Date: April 30, 2026
To: Potential Offerors
From: H. Frank Schneider, Senior Contract Manager
Re: 26-0385 RFP HHSC HBMC NEW PA SYSTEM PROJECT SOLICITATION ADDENDUM No. 01
Questions & Answers.

Date: May 15, 2026
To: Potential Offerors
From: H. Frank Schneider, Senior Contract Manager
Re: 26-0385 RFP HHSC HBMC NEW PA SYSTEM PROJECT SOLICITATION ADDENDUM No. 02
New Drawings and Adjusted Procurement Timetable.

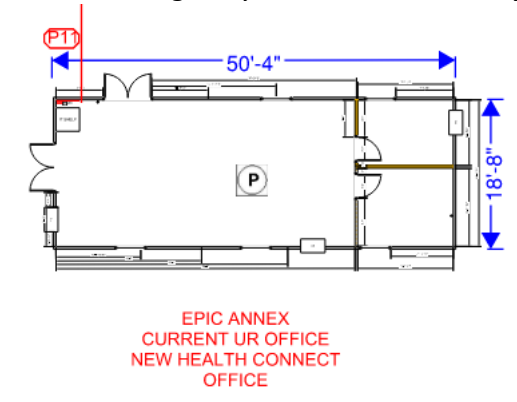
Q3. On sheet PA3-01, there are no speakers shown in the Health Connect Office. Discussion was to add (3) speakers to this building. Please Confirm.

A3. We thought there was PA speaker for the Epic/Healthconnect office. We did

originally have one there, Confirming that the Epic/Healthconnect office requires (3) PA speakers.

1 PUBLIC ADDRESS PLAN - MAINTENANCE SHOP & LR NEW HEALTH CONNECT OFFICE
V09 - 1-3

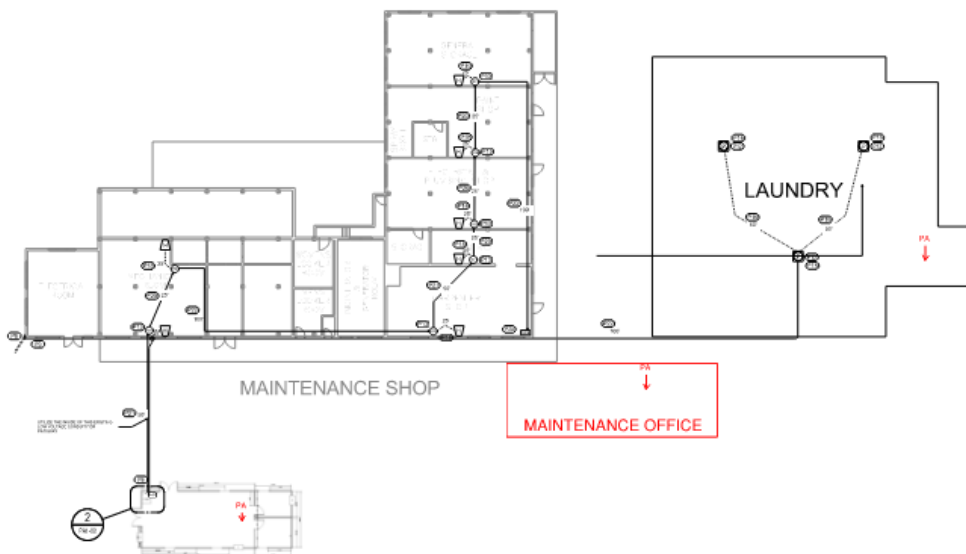
Q5. Current installation at Maintenance Shop is open cabling. A request to provide an add-alternate for this area to be in conduit was made. Please confirm.

A5. Confirmed. Requested by HBMC Facilities as option. See figure provided below in this answer.
